## **SUPPLEMENTAL RESPONSE TO REQUEST FOR ADDITIONAL INFORMATION**

### **APR1400 Design Certification**

**Docket No. 52-046**

**RAI No.: 92-8068**  
**SRP Section: 03.09.05 – Reactor Pressure Vessel Internals**  
**Application Section: 3.9.5**  
**Date of RAI Issue: 07/21/2015**

Figure 6-2 Design of CEA Guide Tube to Fuel Assembly

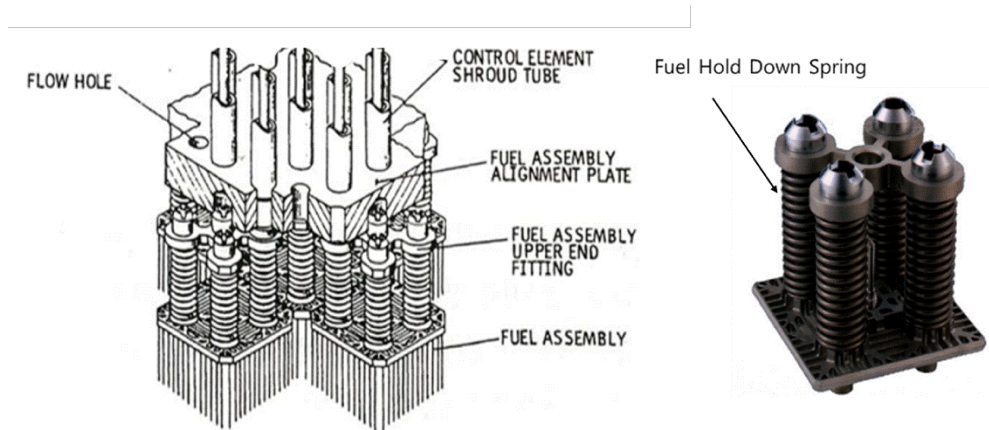
2. The staff also requests additional information about design provisions that would prevent misalignment from the fuel assembly guide posts and its impact on the control element guide tubes and insert tubes after each refueling outage. According to the letter referenced above, after the core is defueled and refueled, a total of 964 tubes (both the control element guide tubes and insert tubes) need to fit into the fuel assembly guide posts when the UGS assembly is lifted and put back into the reactor vessel, on top of the fuel assemblies. If there is any misalignment, the bottom end of these control element guide tubes or insert tubes could be pitched or crimped without any indication. This not only could potentially damage the fuel assemblies due to excess compressive force exerted on them, but in the case of a fuel assembly with control element guide tubes, this could also prevent the CEA from inserting into the fuel assembly if a control element guide tube is

- o Analyses performed for the control element guide tubes and insert tubes in terms of how the structural integrity can be maintained throughout its design life
- o Design provisions to address any misalignment issue during refueling outages when the UGS assembly is put back into the reactor vessel
- o Design provisions to ensure that a similar incident to the Palo Verde event stated above, or other significant operating experience related to reactor internals, will not occur in the APR1400 design
- o Inspection results from similar operating plants that address these issues

The true position requirement for the fuel assembly guide post is determined by taking the allowable CEA guide tube to fuel assembly guide post offset and subtracting the positional tolerance stackups between the fuel assembly center post and the fuel assembly outer guide post centerline, and between the CEA guide tube centerline and the Lower Support Structure/Core Shroud centerlines. The allowable CEA guide tube to fuel assembly guide post offset represents the maximum offset between the centerlines of the CEA guide tube and fuel assembly outer guide post which will permit the chamfered surfaces of the tube and post to engage as shown in Figure 6-1. Therefore, the design accounts for the tolerance to allow for insertability. During re-assembly after refueling, it is the responsibility of the licensee to perform a visual or some confirmation that there is no binding or obstruction that could impact insertability.

The worst horizontal deflection of the CEA guide tube is evaluated in accordance to the ASME Code during level D conditions. The maximum deflection of the guide tube is compared with 80% of the allowable offset of the CEA guide tube. In the APR1400 design, the fuel hold down springs provide a vertical force to prevent vertical movement of the fuel relative to the CEA guide tube during level D conditions. Therefore, there is no vertical deflection of the fuel

assembly guide post relative to the CEA guide tube.

Figure 6-3. CEA Guide Tube

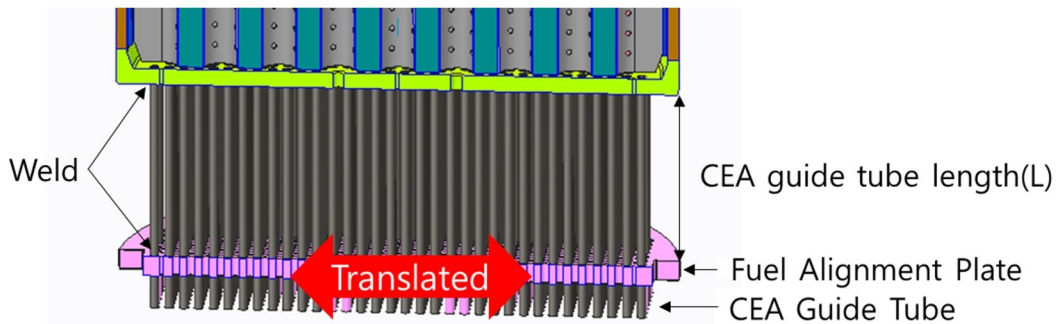
- o The mechanism to prevent the control element guide tubes from buckling during both normal operating conditions and other postulated conditions such as an SSE.

The deflection calculation of the guide tube does not take buckling into account. The maximum deflection (worst case deflection) of the guide tube is calculated using the Level D loads which occur on the lateral deflection of the guide tube. Theoretically speaking, if the guide tube is deflected, it cannot buckle. Therefore, buckling does not occurred in the guide tube. However, the buckling analysis of CEA guide tube is conservatively evaluated in accordance with ASME Code Section III, Subsection NG-3211 and NG-3133

The buckling analysis is performed using Subsection F-1334.3. The details of the evaluation are shown below.

Figure 6-3 shows that the guide tubes are welded on both ends; however, the horizontal movement of the bottom side of the tube ends are not fixed because they are welded on to the FAP (Fuel Alignment plate). Therefore, a translation free end condition is considered conservative. The theoretical effective length of a tube is 1.0; however,  $K=1.2$  is used conservatively (see Table 6-1). The comparison of the results based on the effective length factor is shown in Table 6-2.
